Re: **ADDENDUM NO. 2**

**North Carolina Department of Transportation**  
**Div 7 Support Facilities for Roadside Environmental and Road Oil Operations**  
Graham, NC  
SCO No. 13-10060-01A  
ADW #13070

**C105**

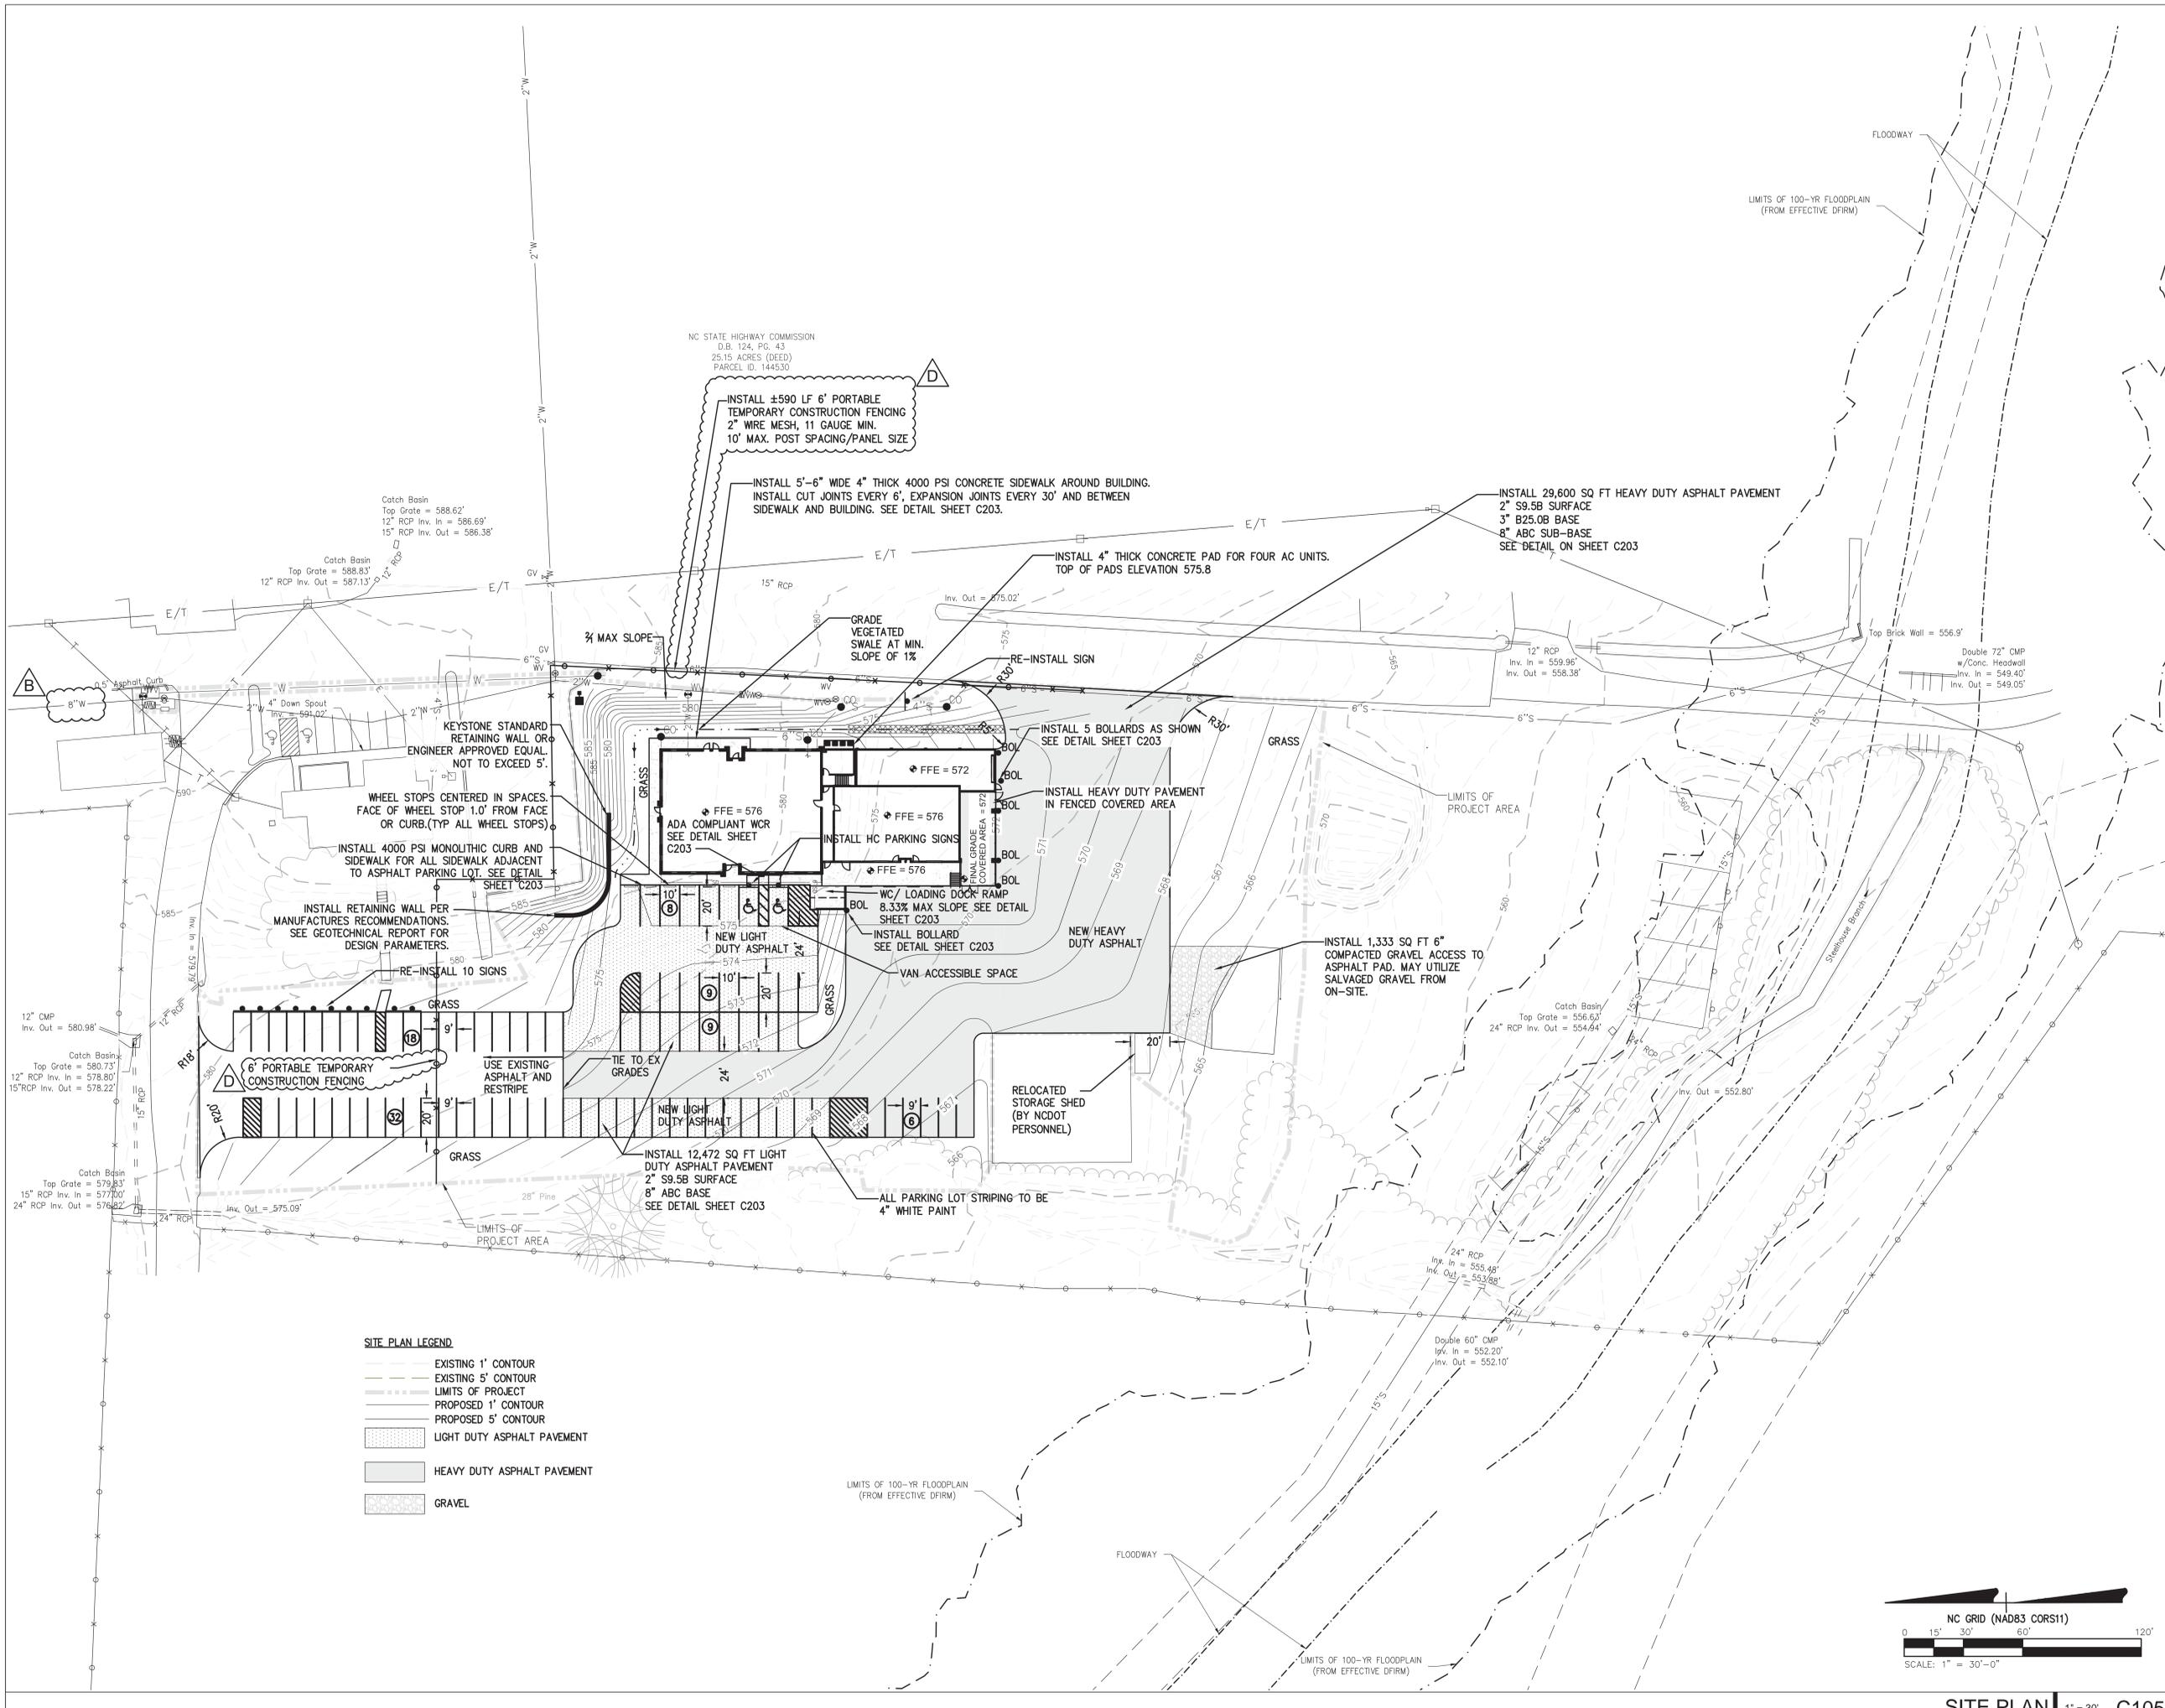
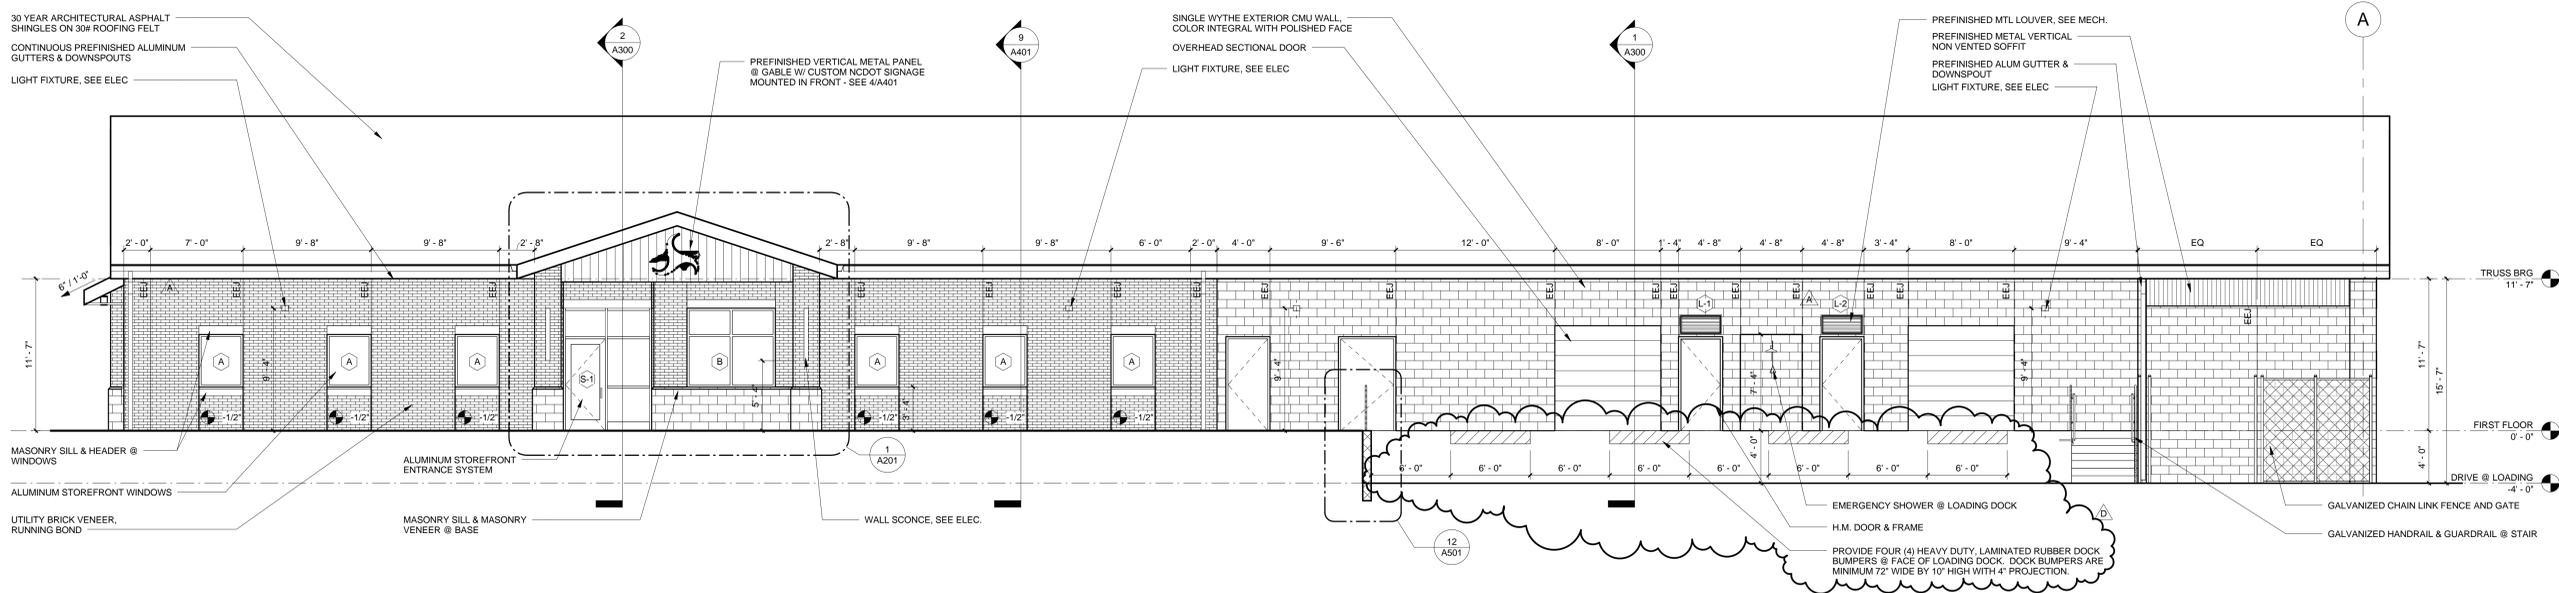
7. Per the Specifications, temporary power is to be provided by the Owner. The power is available on a 6 x 6 post shown on Sheet C102 of the drawings. This post is designated to be removed per the demolition notes but is available for the contractor to use as temporary power. A power meter is existing and an electrical panel is existing on this pole. The panel has 2-100 Amp/2 pole breakers, 1-60 Amp/2 pole breaker and 1-20 Amp/1 pole breaker. Any extension of power from this panel for the Contractor's use shall be provided by the Contractor.

1. C105 – temporary construction fencing has been added
2. A200 – additional information provided regarding loading dock bumpers
3. A700 – information regarding building signage has been added
